UNITED STATES PATENT AND TRADEMARK OFFICE

Office Action Summary

09/804,012

DETAILED ACTION

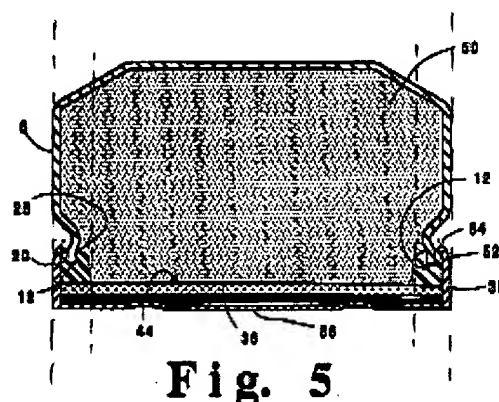
Bennett teaches an anode cup [2] having an upper external diameter defined by peripheral wall [6] and a lower peripheral diameter defined by wall edge [14]. (col. 4 line 58-66) The cup has a closed upper end [4] and an open lower end [8]. (Figure 1, claim 2) A first and second vertical height joined to respective first and second points and having corresponding curved corner radii defining a step [10] is shown as follows: (from Figure 1)

The edge portion [14] is also considered to read on the instant “substantially vertical portion”.

As to a ratio of the upper diameter to the lower diameter being greater than or equal to 0.86, it is reasonably presumed that Bennett teaches or at least suggests this feature as the bead [10] is specifically disclosed to curve *inwardly* resulting in the lower peripheral wall being indented in that same direction. In fact, the lower peripheral wall is indented to an extent equal to the sum thickness of gasket [20] and upstanding wall [34]. (col. 4 line 63-67) As a result, the upper peripheral wall would naturally flow to have a diameter greater than that of the lower peripheral wall and would result in a ratio greater than unity.

As to a ratio of cup height at the upper diameter to that of the lower diameter not being greater than about 2.19 (claim 1) or the difference between heights being greater than zero (claim 2 and 16), Bennett teaches that the step [10] is positioned at 5% to 40% of the wall height. Taking the indented area as the demarcation point in which the upper peripheral wall and the lower peripheral wall meet, in one respect the upper peripheral wall is at 60 % of the total wall height while the lower peripheral wall is at 40%. The resulting ratio of 1.5 is not greater than 2.19.
